MEMORANDUM

RE: Response to Comments on NOI for DEP #CE 204-0991, The Reconstruction of Foster Street in Littleton, MA

RE: Stormwater Analysis
Reconstruction of Foster Street Project (MassDOT Project #609054)
MassDEP File #204-0991

JORDAN S. MCCATHERIN
BK/PG 62917/52
PARCEL #R10 1 0
277 FOSTER STREET

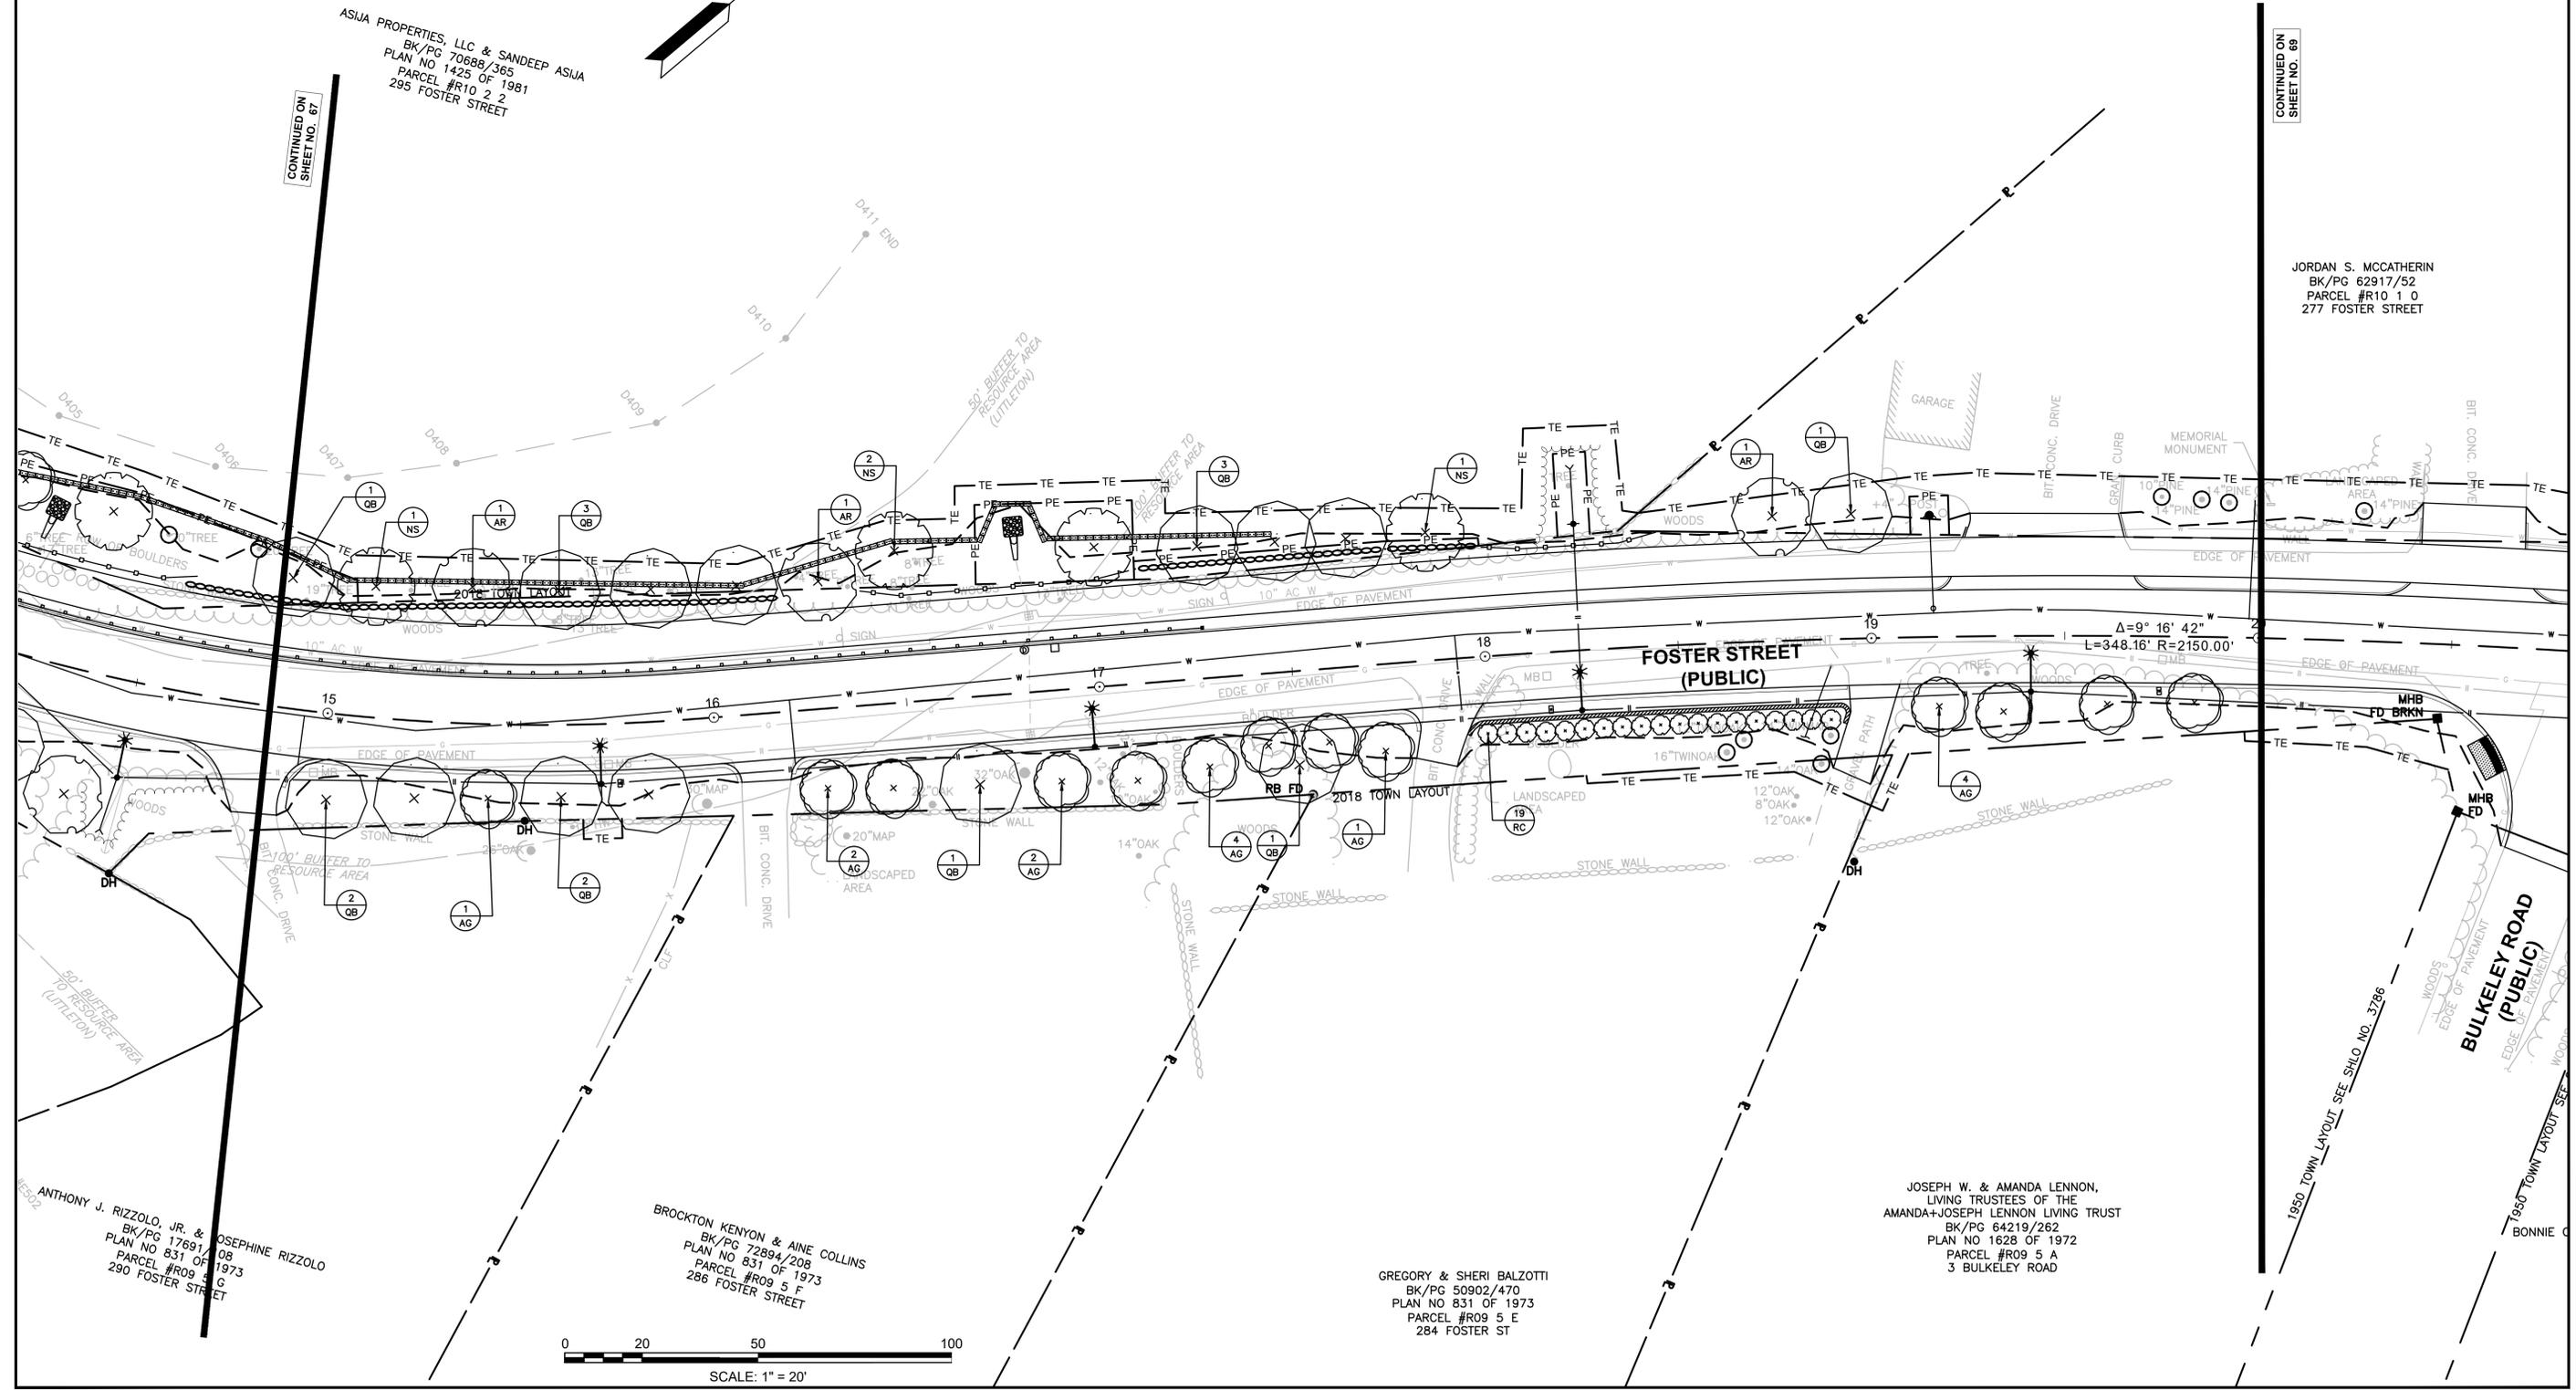
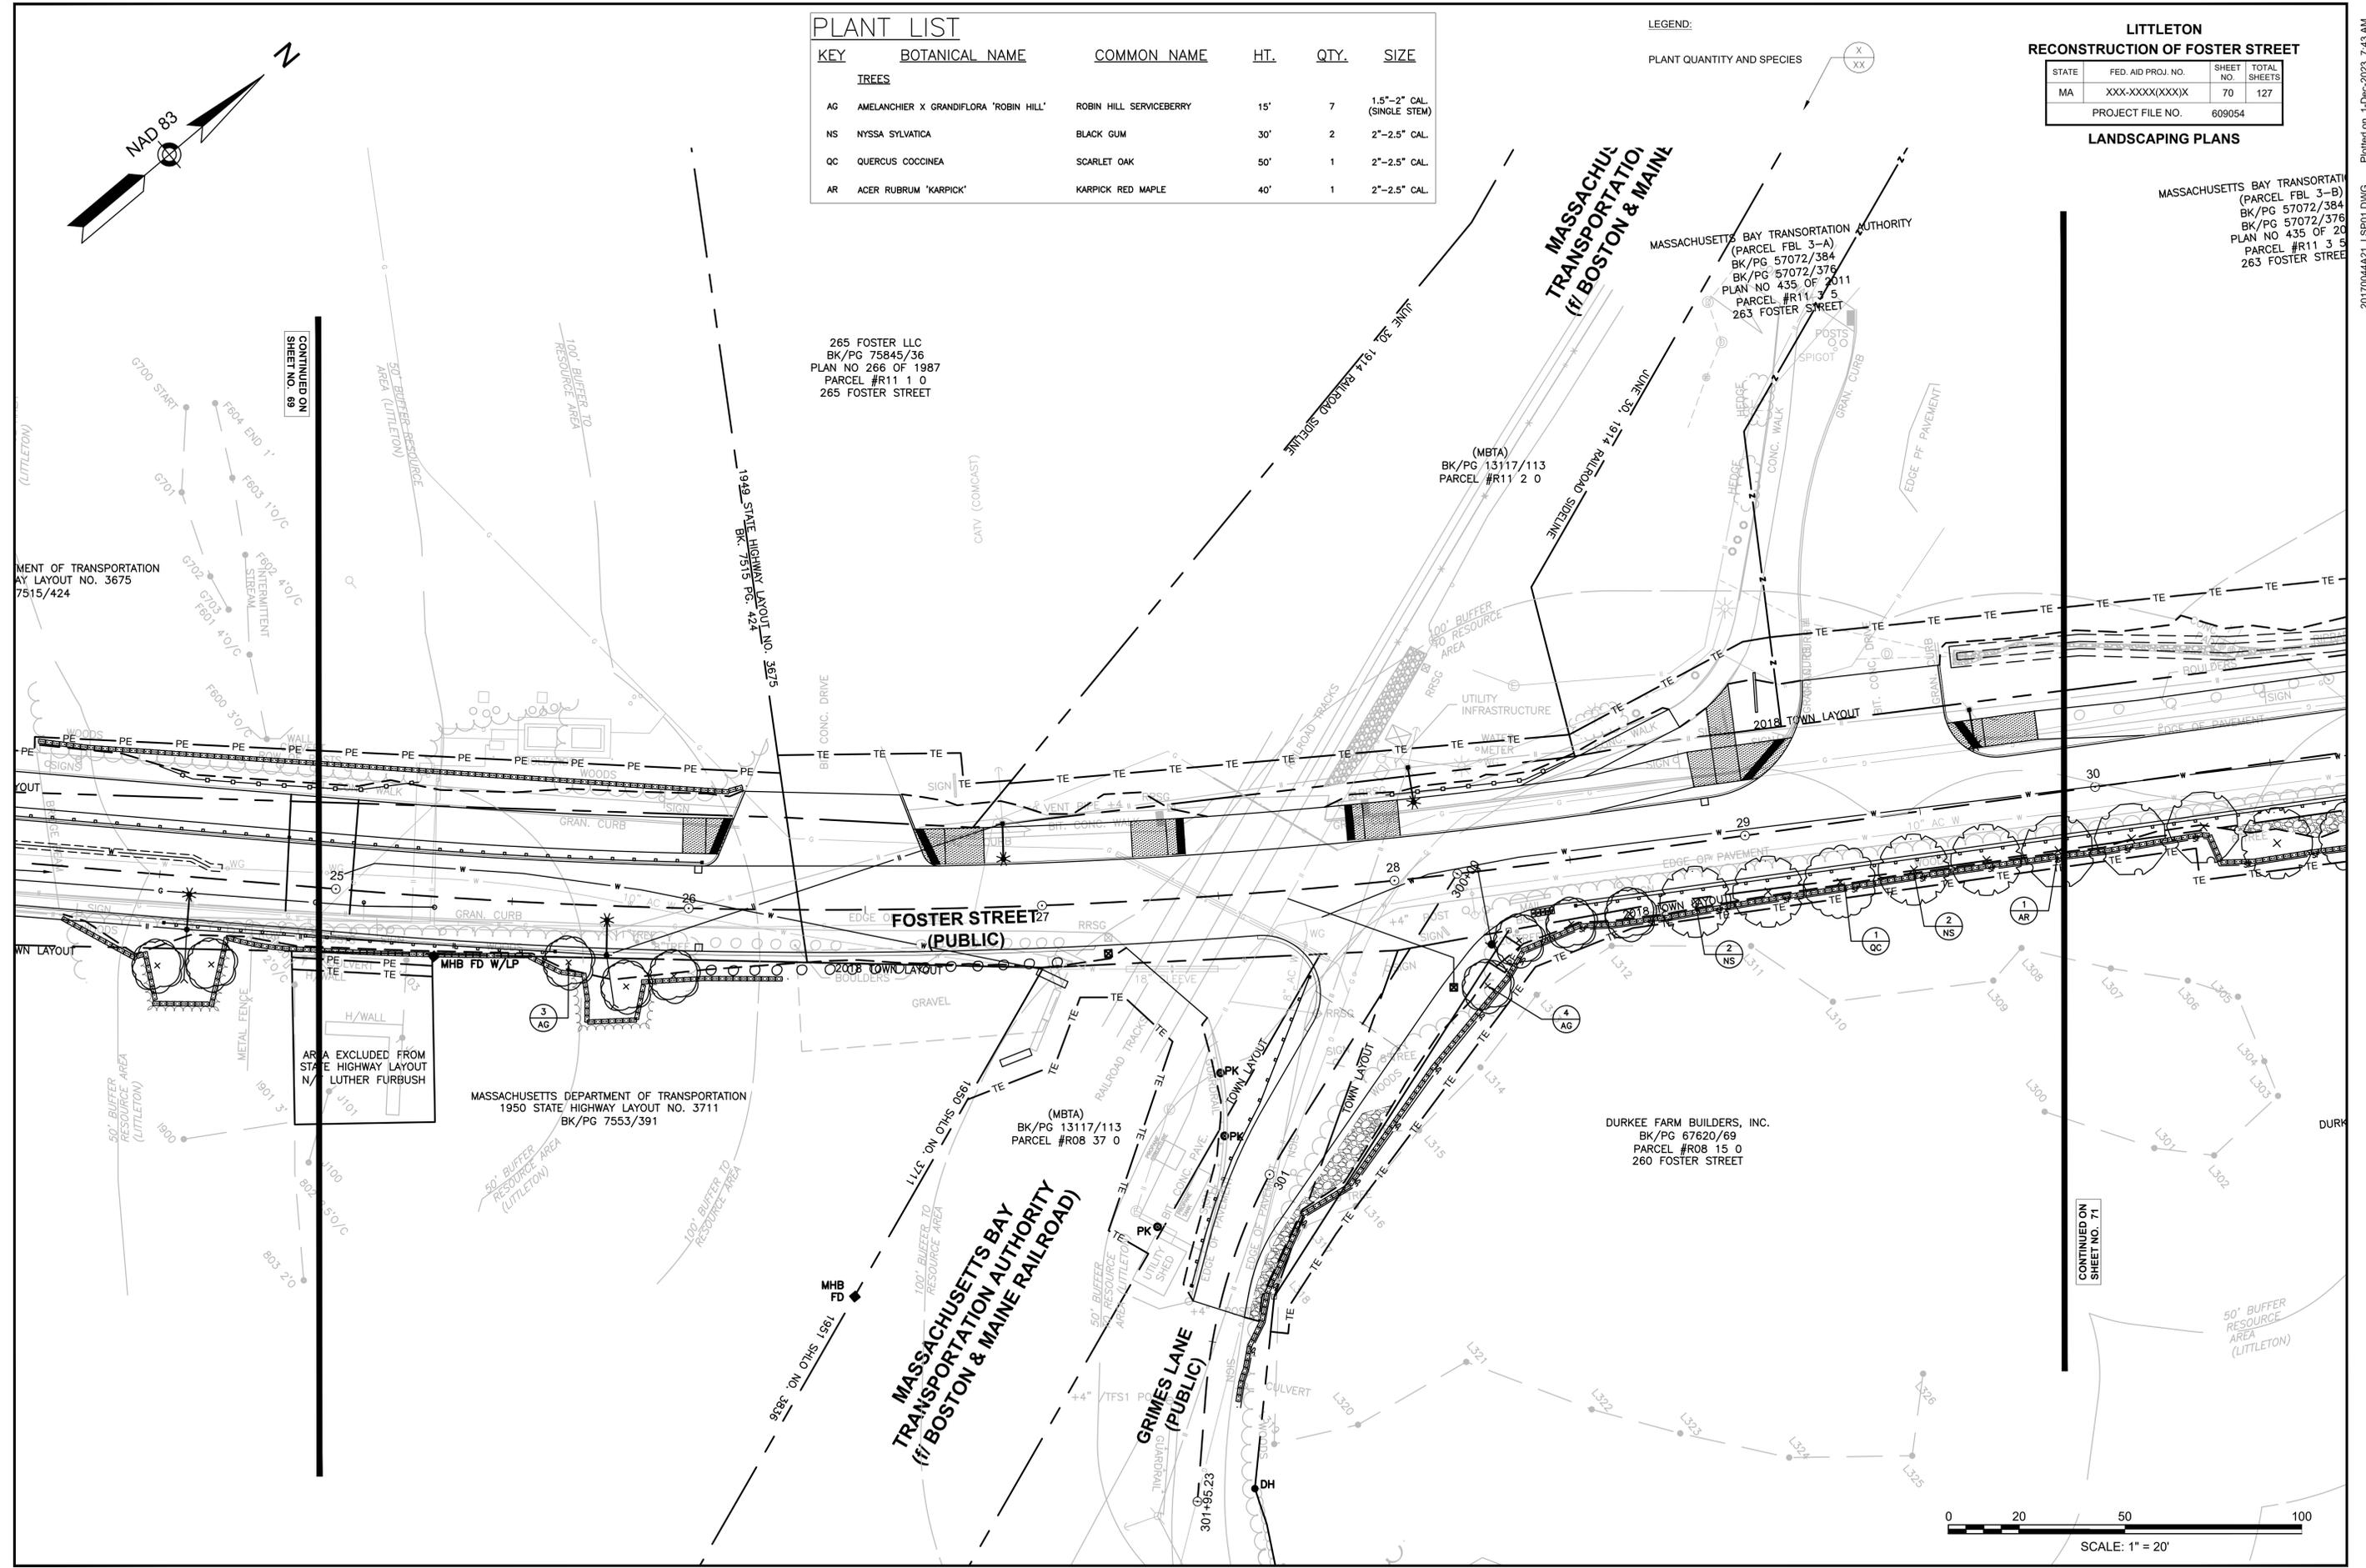
- Commissioners requested a tree inventory of trees to be taken at the 260 Foster St parcel including station, size, and species. A commissioner stated a replacement ratio of 2:1 was advised. Older and larger trees should be replaced at a higher ratio. Commissioners noted that trees likely to die as the result of the work (e.g., due to backfill around the tree base) need to be considered as tree removals.

F&O Response #6: F&O created a tree inventory in the 100-foot Buffer Zone listing trees that will be impacted from slope construction. The inventory lists proposed replacement tree quantities and species and is included in Attachment 5. The proposed tree replacement ratio is 2:1. The replacement trees were selected from the Town of Littleton Tree Guidelines document. New planting plan sheets showing the location of proposed tree replacements are also included in Attachment 5.
